SOUTH TEXAS PROJECT, UNIT 1

AMENDMENT TO FACILITY OPERATING LICENSE

Amendment No. 97
License No. NPF-76

ATTACHMENT TO LICENSE AMENDMENT NOS. 97 AND 84

Figure 2.1-2

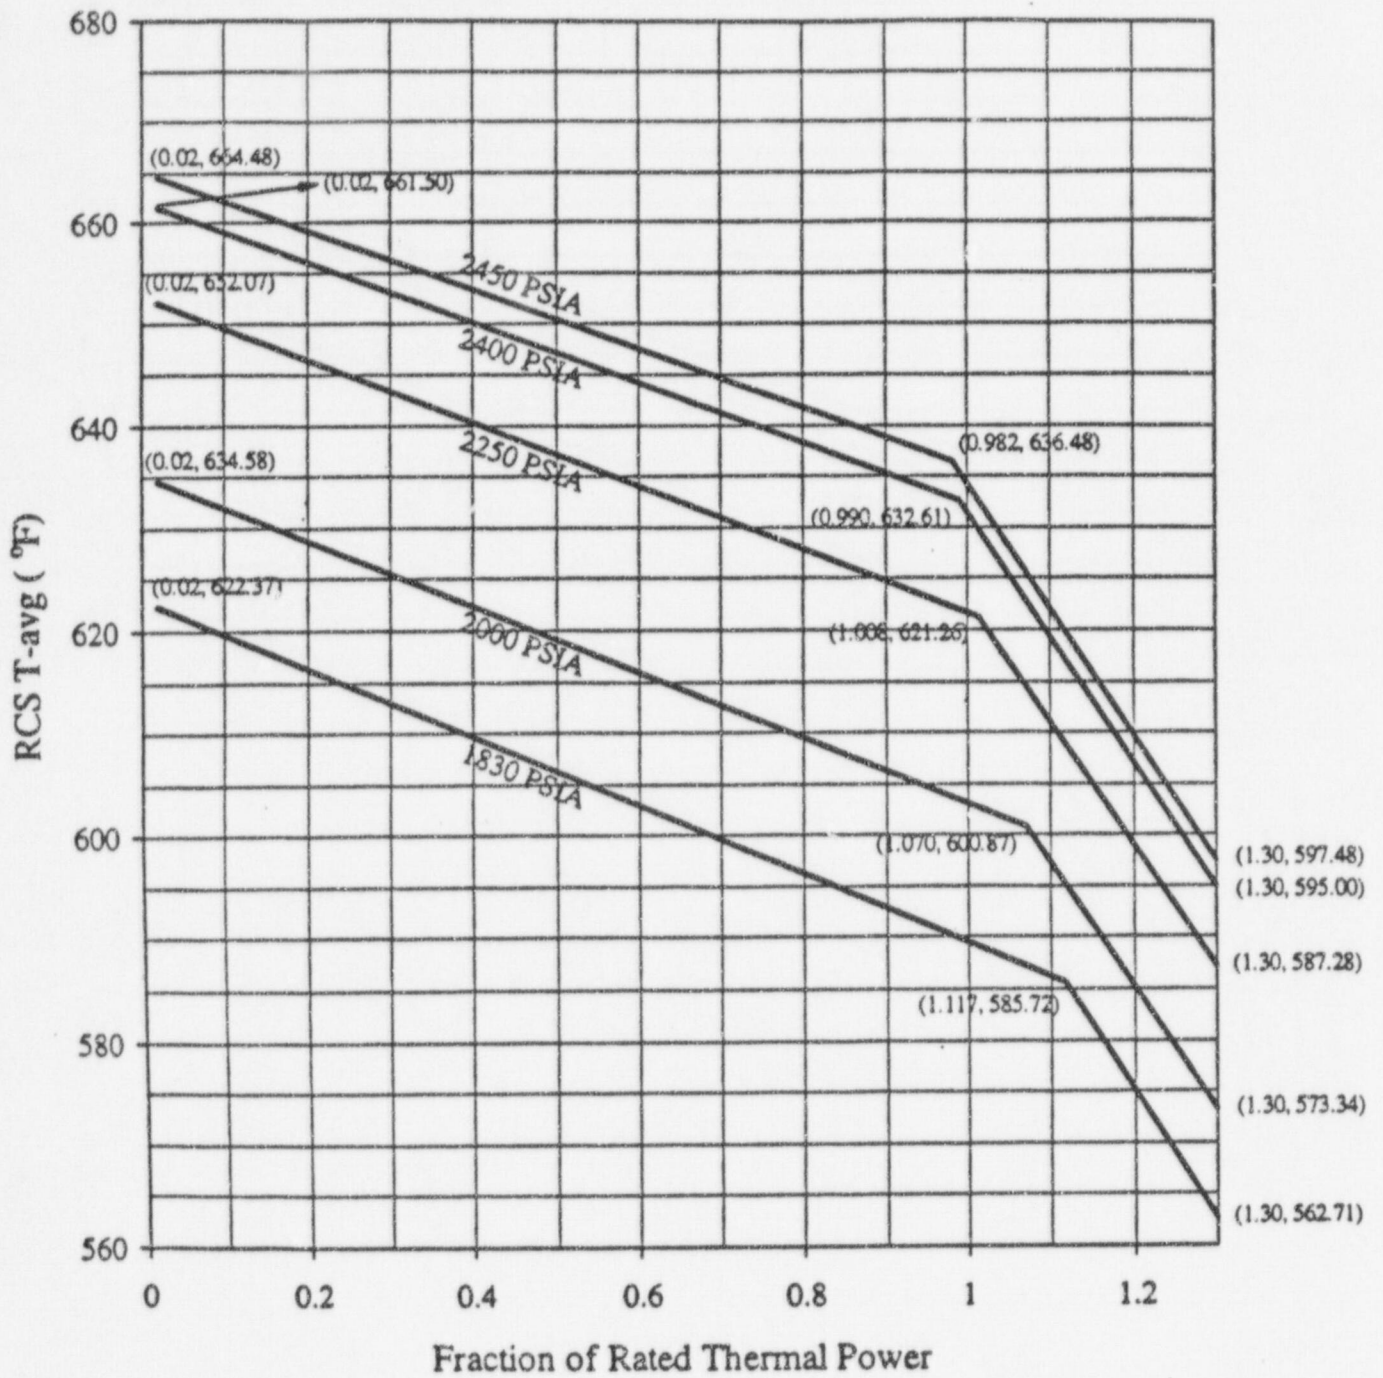
2.1.1 The combination of THERMAL POWER, pressurizer pressure, and the highest operating loop coolant temperature (T_{avg}) shall not exceed the limits shown in Figure 2.1-1, or in Figure 2.1-2 when operating under alternate operating criteria consistent with reduced Reactor Coolant System flow as addressed in Technical Specification 3.2.5.
